# RIVERBEND CROSSING FILING NO. 1

## STREETS, STORM & STRIPING

### CONSTRUCTION PLANS

PCD File No. SF-18-044  
Unresolved.

FOREBAY 'A' DETAIL  
SCALE: N.T.S.

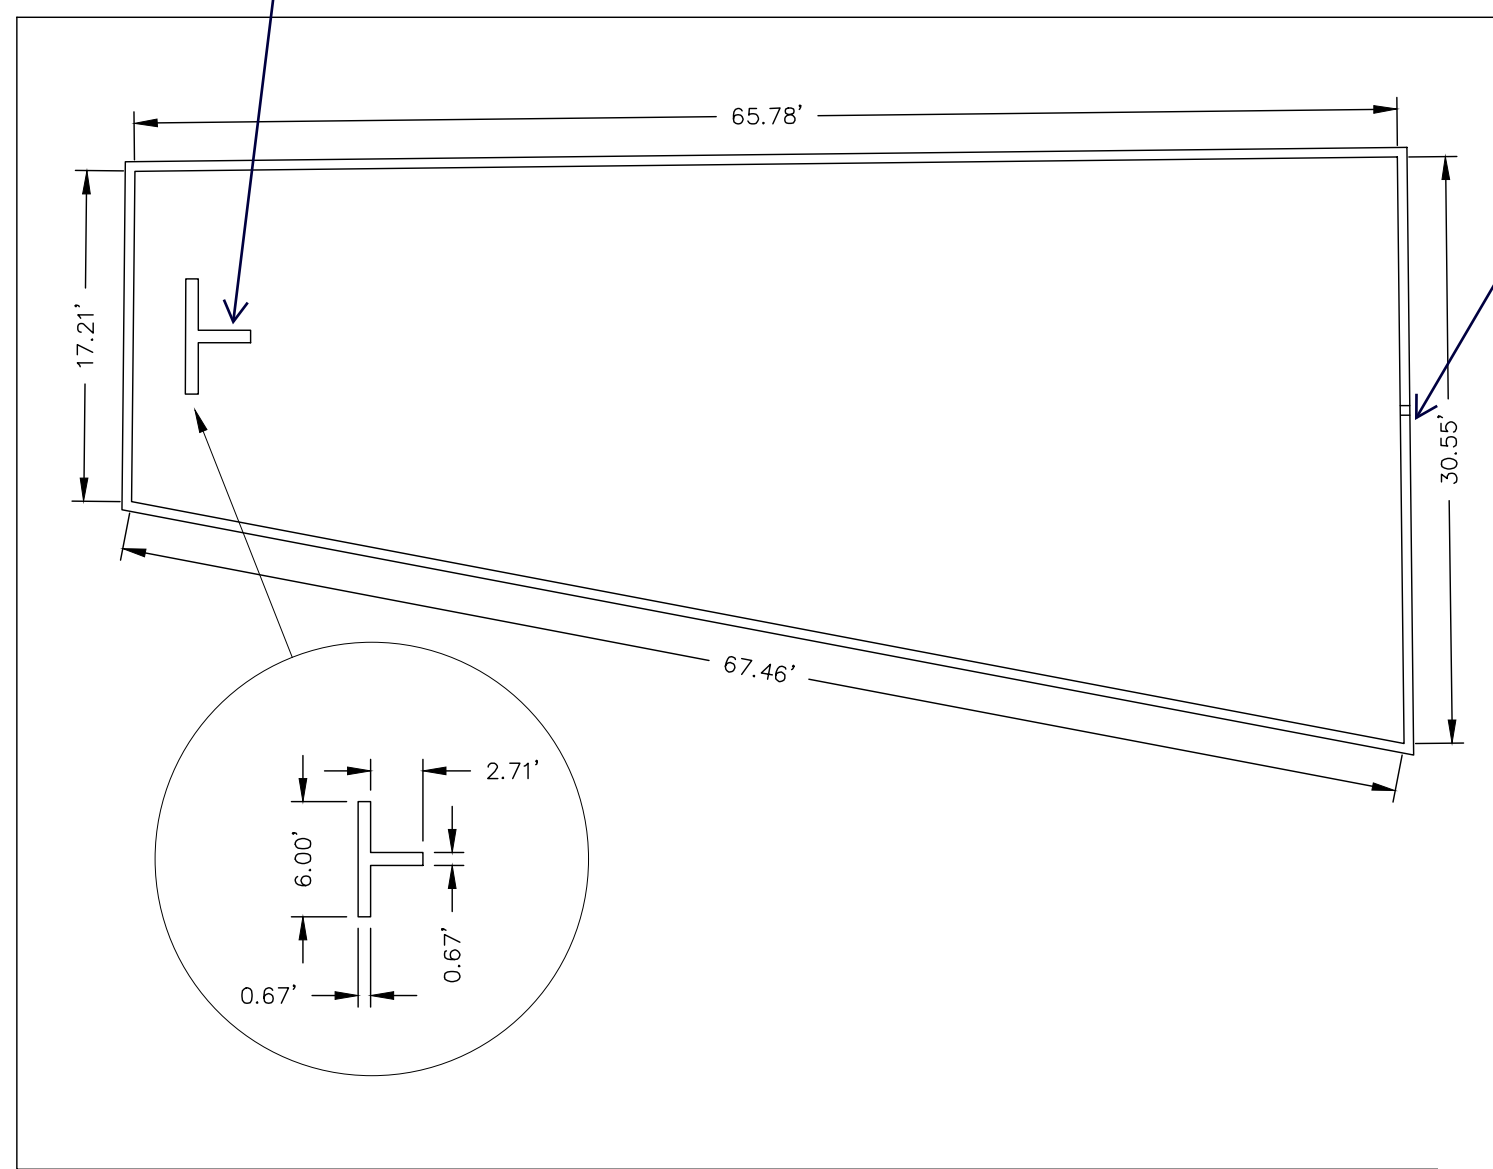
provide additional detail for the baffel structure. Provide calculation in the drainage report.

provide detail of notch. Identify notch location to match with the trickle channel.

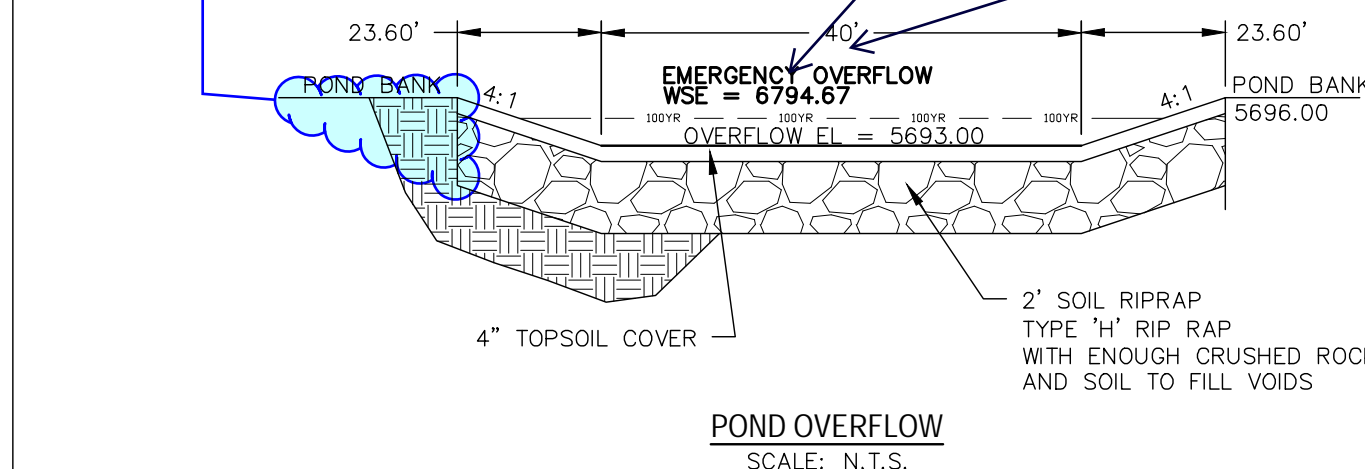
Revise to continue the 4:1 to the top of bank. Unresolved.

Update spillway cross section. Does not match the design.

Provide profile cross section detail of the emergency spillway. The riprap must extend beyond the top of the channel. Unresolved.
